MY3 FINAL MONITORING REPORT  
Buffalo Creek Tributaries Mitigation Project  
Johnston County  
Neuse River Basin  
CU 03020201

DMS Project # 100042  
DMS Contract # 7422  
DMS RFP # 16-007279  
USACE Action ID Number: SAW-2018-00425  
DWR Project # 2018-0199 V2  
Calendar Year of Data Collection: 2023

**RE: WLS Responses to NCDEQ DMS Review Comments for Task 9 Submittal, Draft Monitoring Year 3 Report for the Buffalo Creek Tributaries Mitigation Project, DMS Full-Delivery Project ID #100042, Contract #7422, Neuse River Basin, Cataloging Unit 03020201, Johnston County, NC**

FIGURE  
**1C**

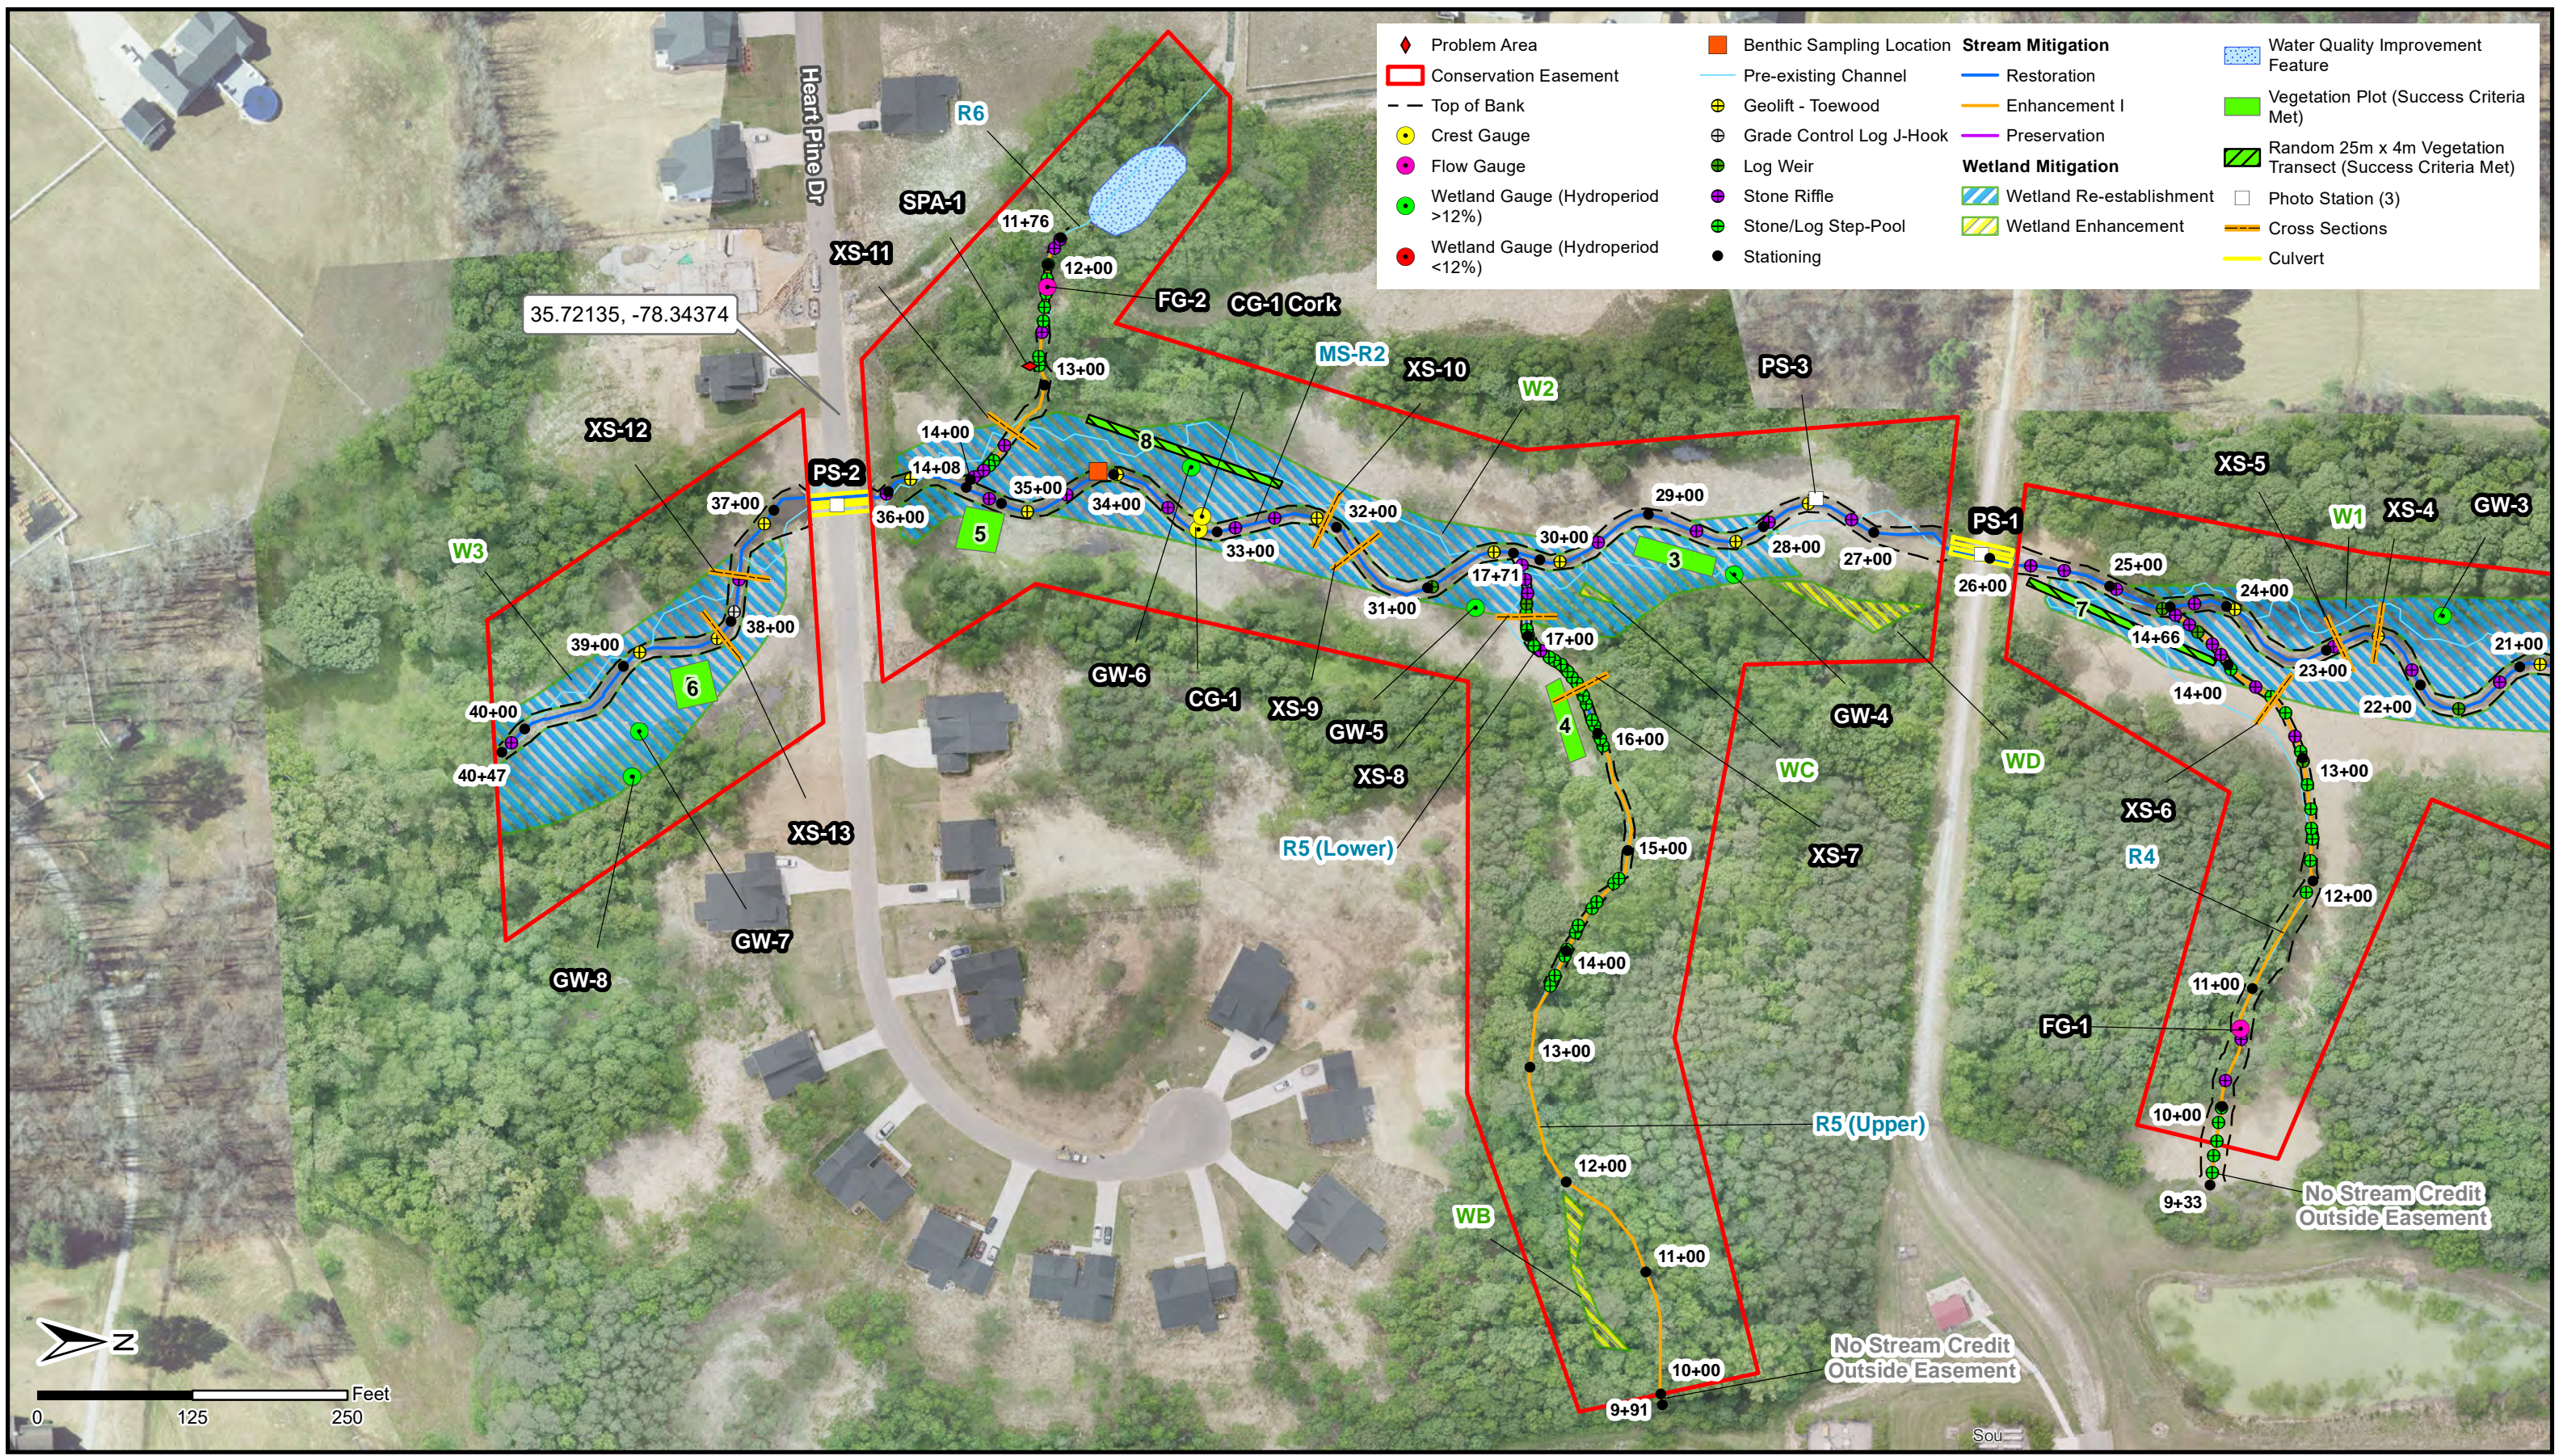
1. **Figure 1c: Groundwater well 8 is missing from the CCPV; please update.** WLS Response: Groundwater well 8 has been added to the CCPV.
2. **Pg. 11, Section 4.3: Failure of groundwater well 1 to meet success criteria for all monitoring years is concerning. Consider adding additional gauges here in MY4 and elaborate on site conditions in the narrative. If failure of the gauge continues, WLS will need to identify the extent of the at-risk wetlands and discuss in next year's monitoring report.** WLS Response: WLS will be installing an additional groundwater well in W1 near GW-1 at the beginning of MY4. Additional verbiage has been added within the narrative describing the

## Buffalo Creek Mitigation Site Rainfall Data

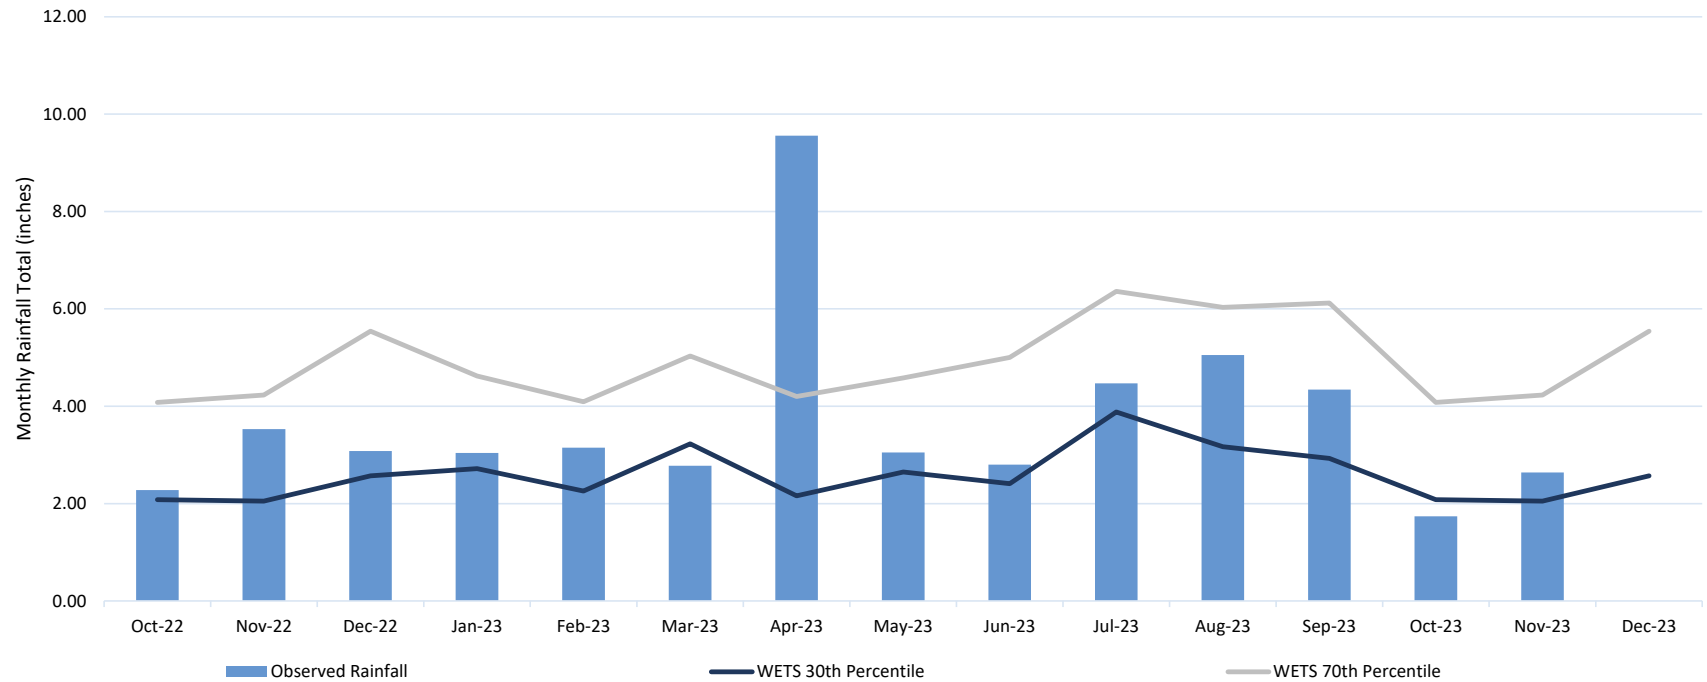
6. **Appendix D, Rainfall Table: Please update with rainfall through November if possible.** WLS Response: Rainfall data through November 2023 has been updated in the Appendix D Rainfall Table.
